Mitigation Plan

Cow Tail Mitigation Project

FINAL VERSION

SUBJECT: NCIRT Review and USACE Approval of the NCDMS Cow Tail Mitigation Site / Columbus County, Action ID SAW-2023-00196

SHEET NAME
TYPICAL SECTIONS

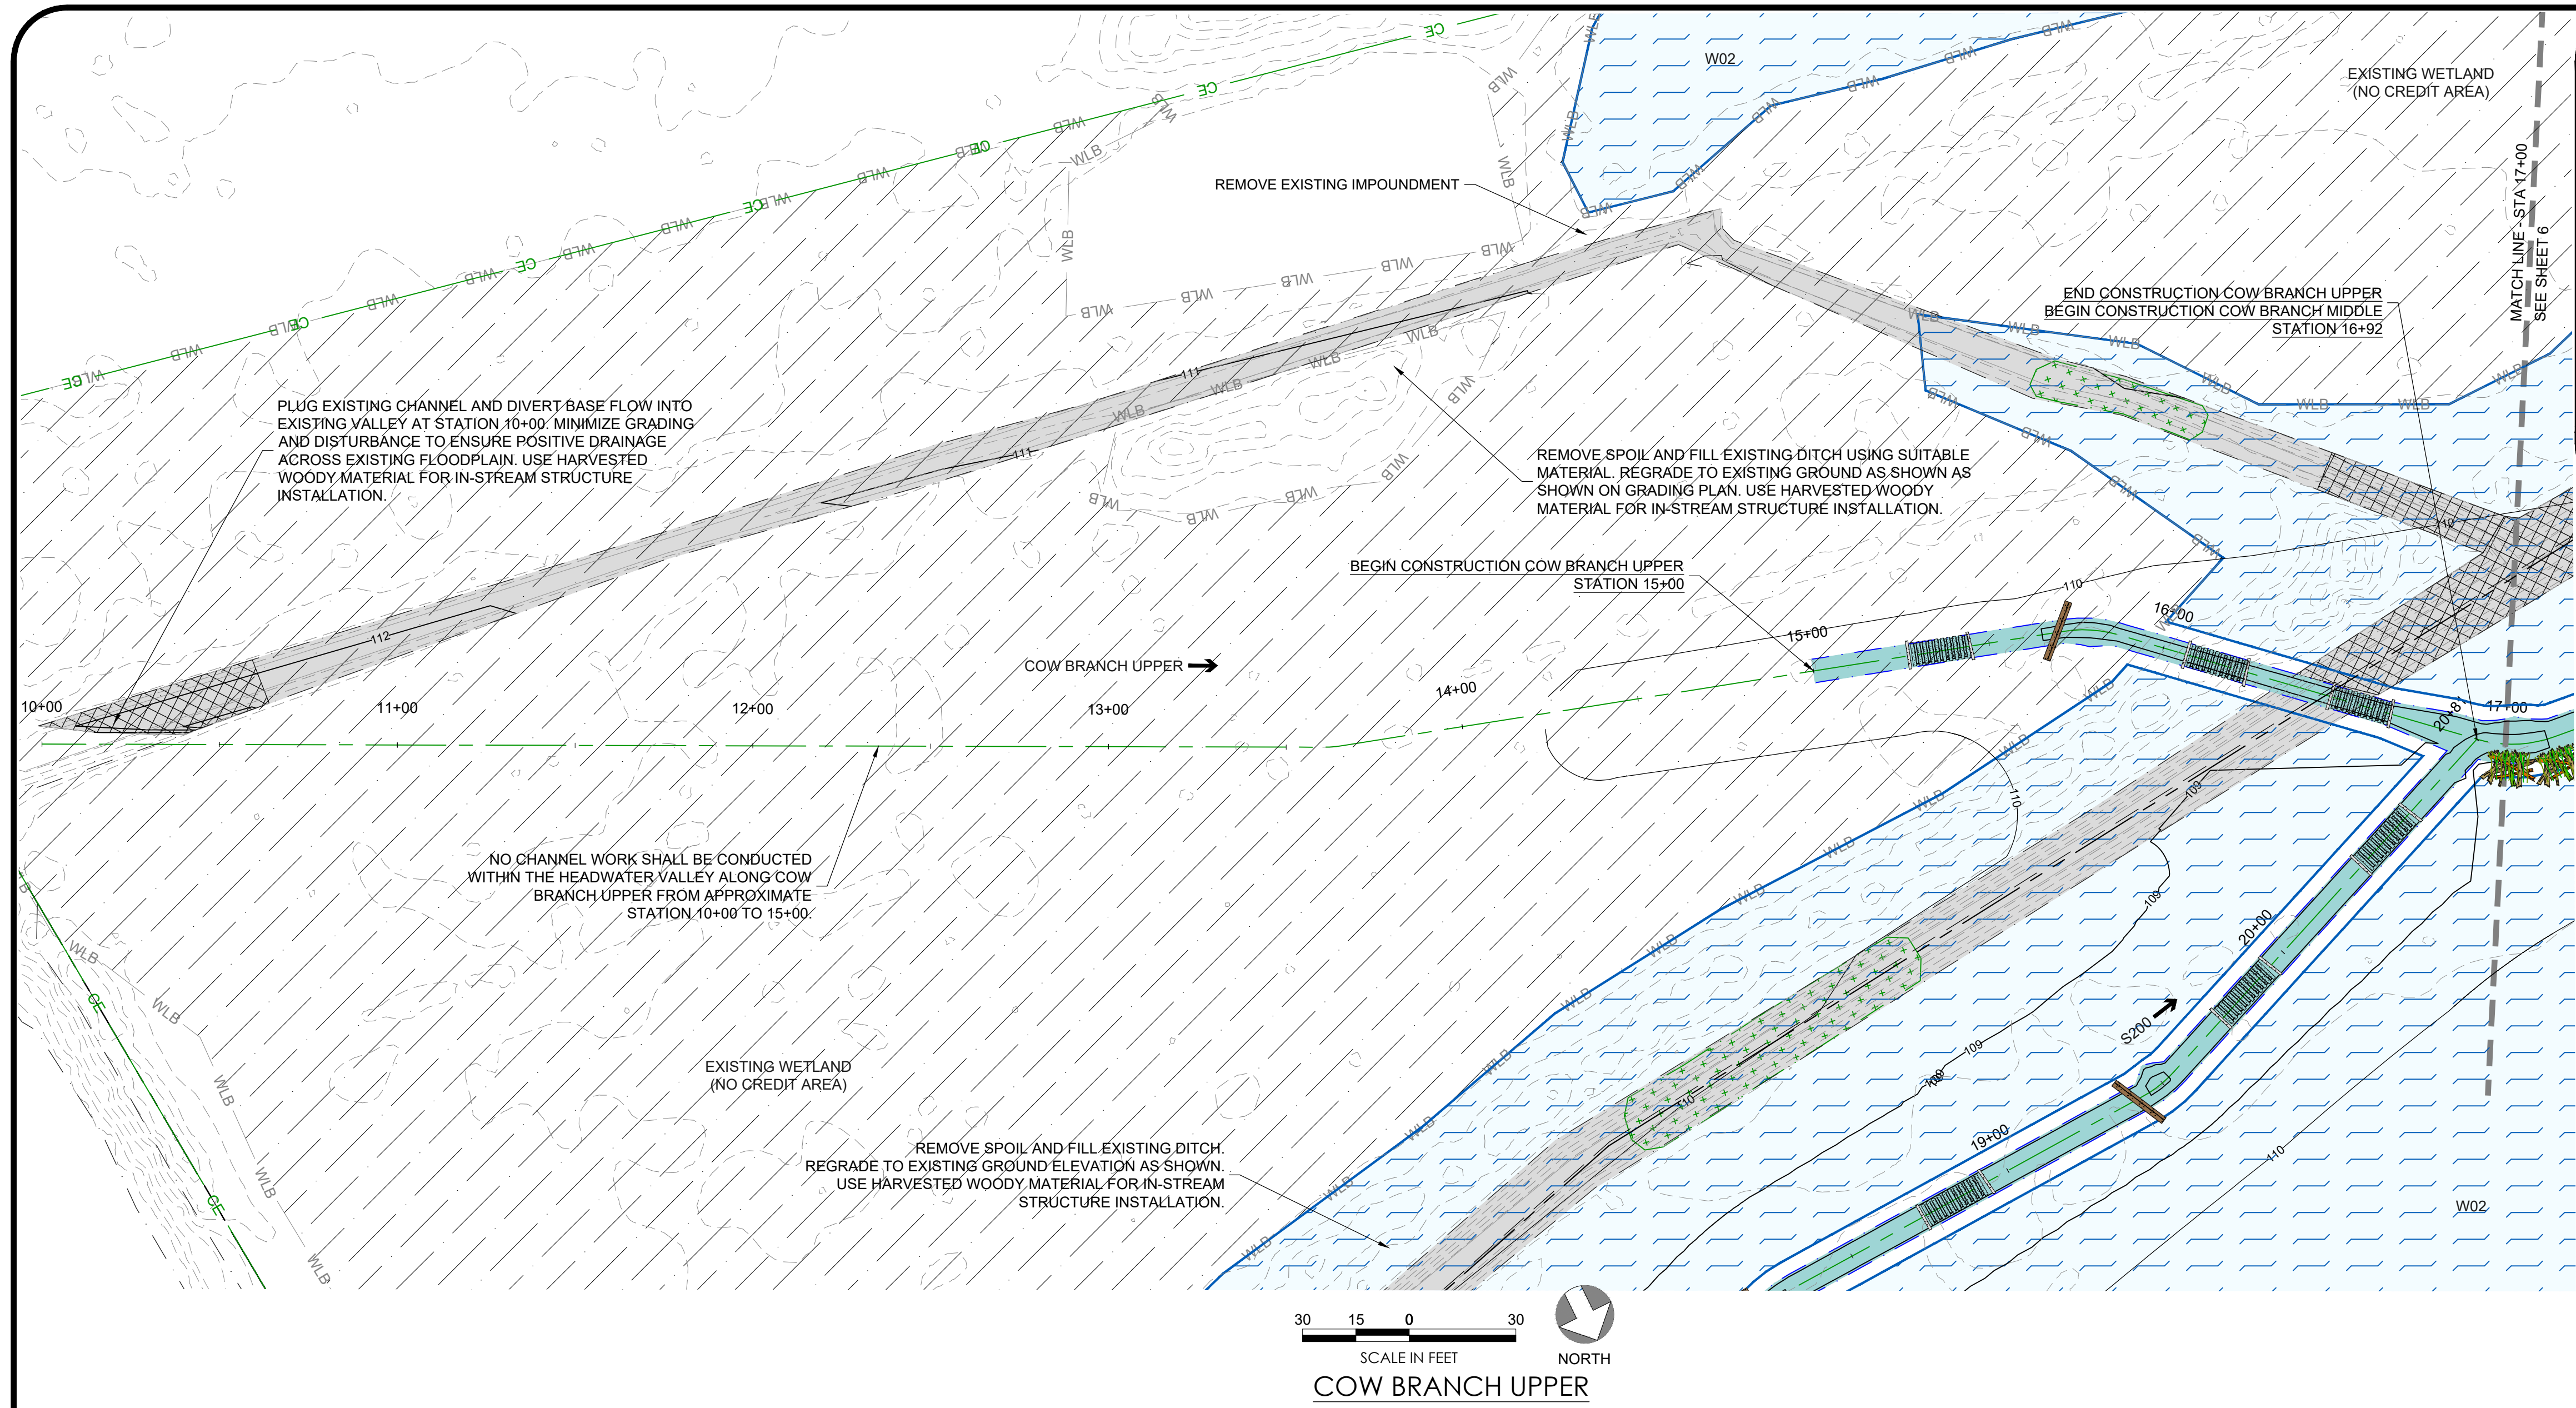
23. Sheet 4 – Please explain the typical sections for S100, S200 and Cow Branch Upper. Are riffles, pools and bankfull features proposed for these headwater valley reaches?

Response: The typical sections and morphology parameters shown on plan sheet 4 are correct. We have added the stationing for upper Cow Branch to distinguish between headwater stream valley (no credit length) and single-thread channel restoration. As noted/clarified in response comments above, all reaches are being proposed for single-thread channel restoration, except for upper Cow Branch in a non-creditable area from station 10+00-15+00 and S200 from station 10+00-14+50.

PERMANENT CULVERT CROSSING
 NOT TO SCALE

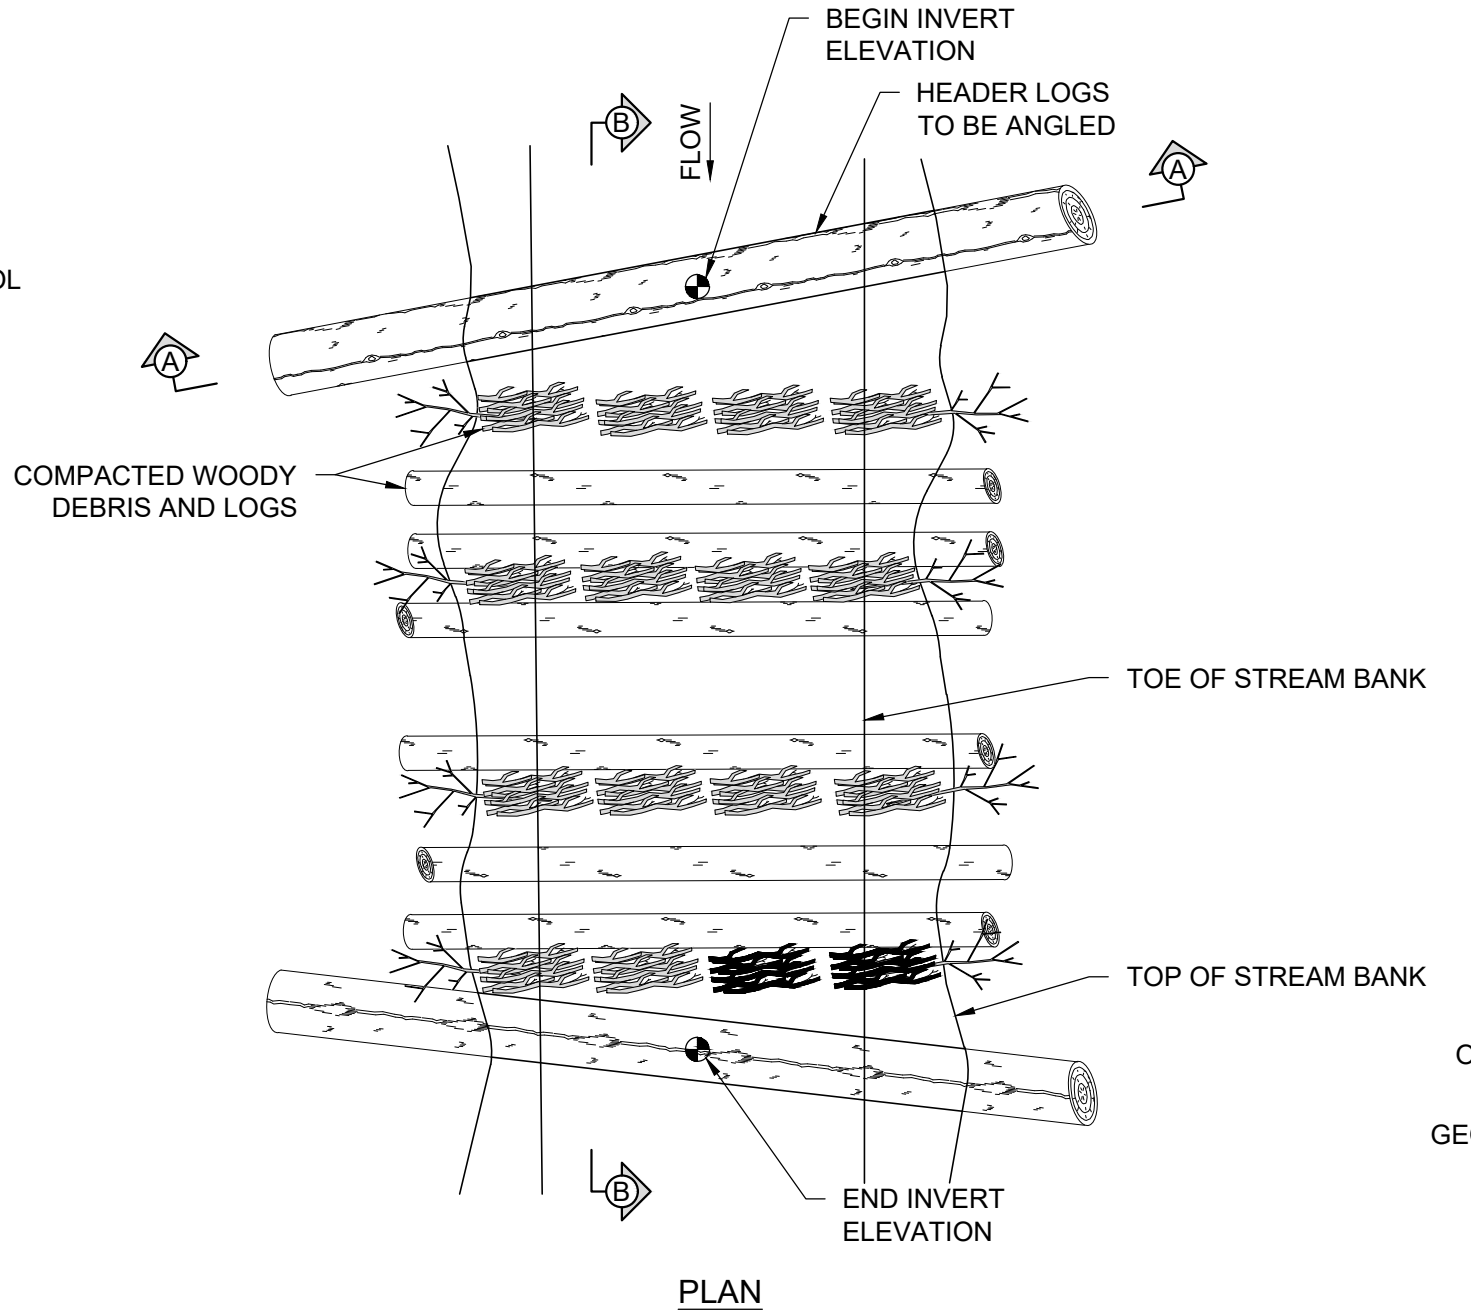
7. Plan Sheet 20: A spec for a permanent culvert crossing is shown, but I do not see a crossing shown on the plans. Section 3.7.9 also states that there are no stream crossings. Please confirm that no stream crossings are proposed and remove the culvert crossing spec from the plan, or update text and figures to clearly show the location of a crossing.

Response: The two permanent culvert crossings are now shown on plan sheet 13 and the callout text has been added/revised. The culvert crossings are located at non-jurisdictional ditches outside of the conservation easement and creditable areas. Section 3.7.9 and plan sheet 13 have been revised for clarification.

LOG STEP POOL

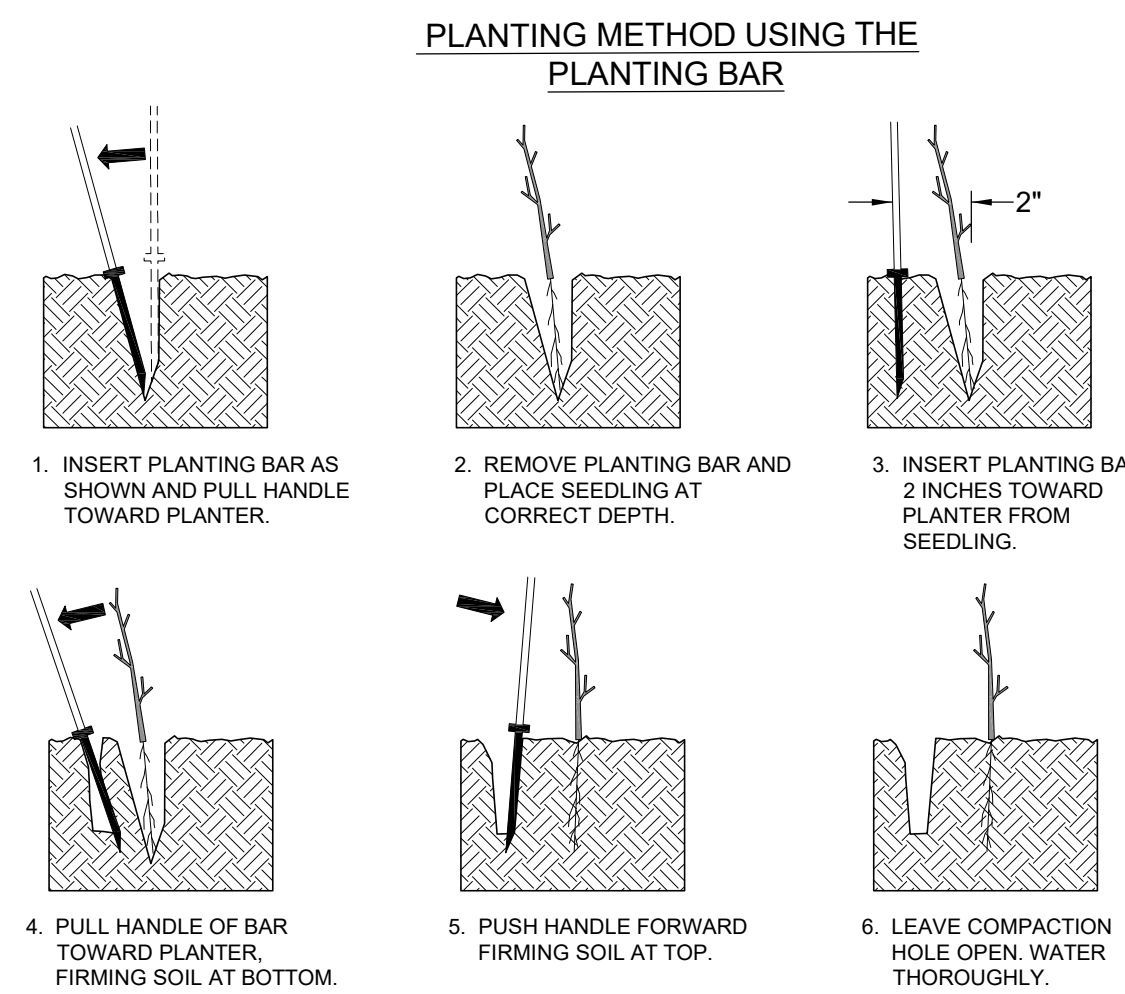
9. Plan Sheet 22, Log Step Pool Spec: “Stone backfill or suitable soil material” is proposed for this structure, but “stone” is not defined in terms of size or percentage of fill. It is helpful to the reviewers to be able to see this information as excessive or large stone has been an issue on coastal sites in the past.
